Service Letter: No. 329

Subject: Condenser Scoop Bellcrank Replacement & Adjustment Procedure.

Applicability: Bell Helicopter Model,407,427 Equipped with the Air Comm Air Conditioning system.

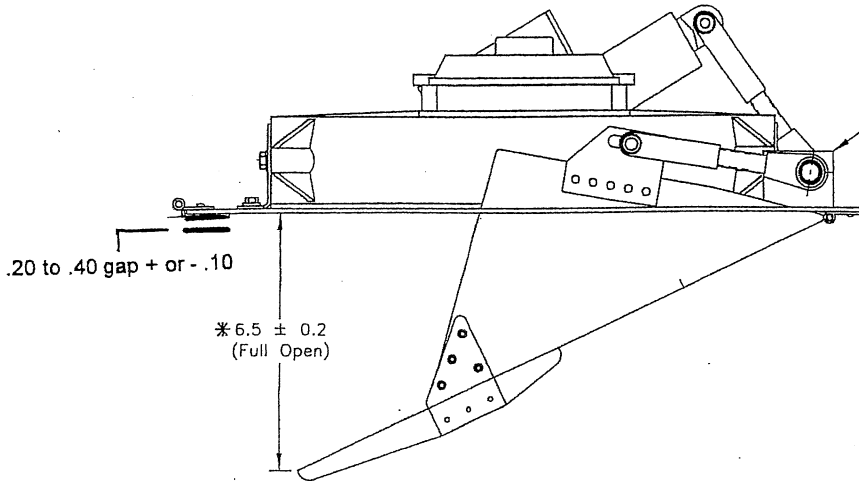
4. Remove hardware from the three clevis / fork ends that attach the bellcrank to the scoop and actuator assemblies.
5. Remove bolts from the bellcrank retaining blocks, remove the old bellcrank S-7036EC-7 and discard. (If applicable).

6. Install new bellcrank assy. S-7037EC-1 in to existing retaining blocks and torque existing nuts to 20 to 30 inch lbs.
7. Install new Clevis ends (S-7036EC-41) on the new bellcrank assy., and temporarily install existing hardware, attaching the actuator arm assy.
NOTE: It maybe necessary to remove a small amount of material from the sides of the actuator attaching point, to allow the free movement of the Clevis end on the actuator arm.

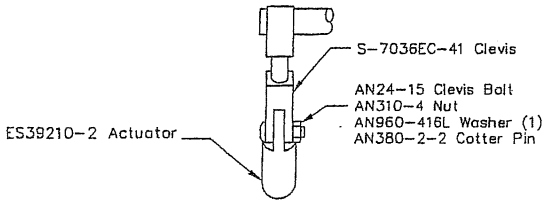
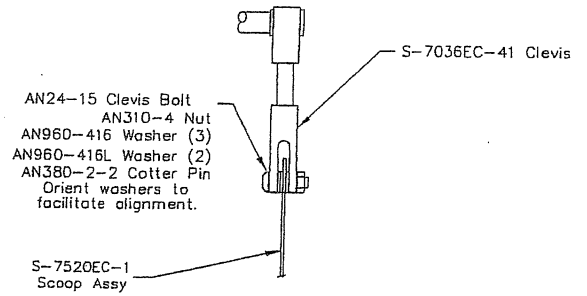
8. Reinstall existing Fork ends on the new bellcrank rod ends and temporarily attach the scoop door using existing hardware. Fork ends will need to be adjusted so there is a gap of approximately .20 to .40 inch between the scoop plate assy. and the scoop door. See drawing on page 3 of 3.
NOTE: This gap is necessary prevent the bottoming out of scoop door before the limit switch has turned the actuator motor off.
